## Product Change Notice (PCN)

**PCN Number:** PCN-0451156R-01

**Product(s) Affected:** PJ-039A, PJ-039B, PJ-039AH, PJ-039BH

Current version	New version
Outlook		
Front	<p>without chamfer</p> 	<p>with chamfer</p>

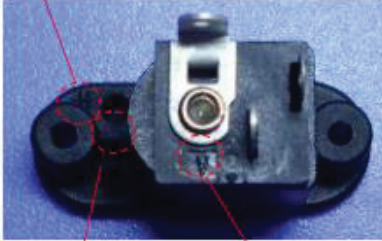
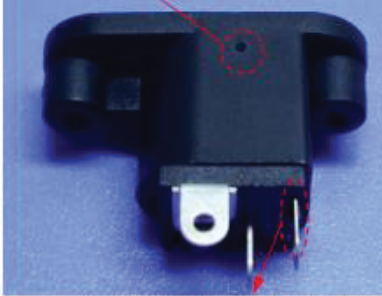
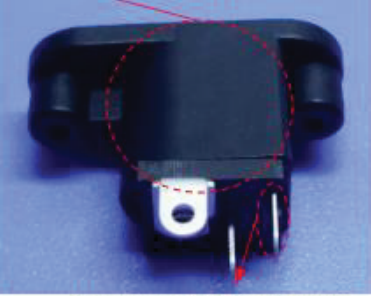
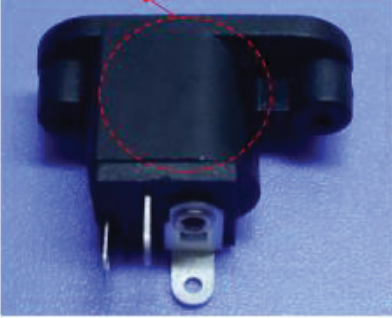
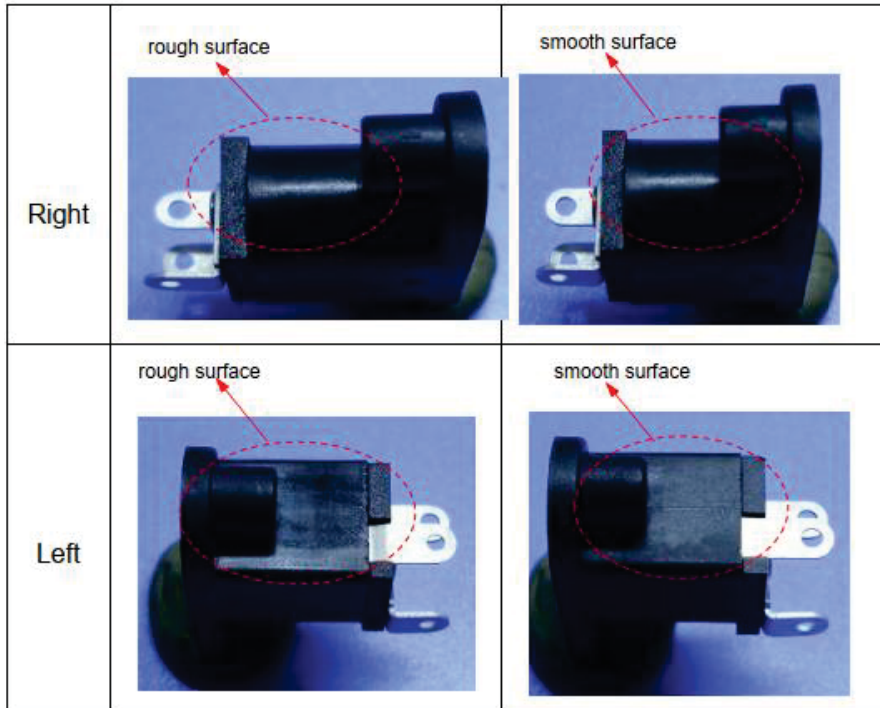
**Description of Change:** Thickness of pin 2 changed from 0.2mm to 0.25mm. Aesthetic changes as shown in below comparisons:

Back	<p>cave marking location</p>  <p>smaller</p> <p>cave marking location</p>	<p>cave marking location</p>  <p>thicker</p> <p>cave marking location</p>
Top	<p>with injection mark</p>  <p>thickness of pin#2 is 0.2mm</p>	<p>without injection mark</p>  <p>thickness of pin#2 is 0.25mm</p>
Bottom	<p>without injection mark</p> 	<p>with injection mark</p>
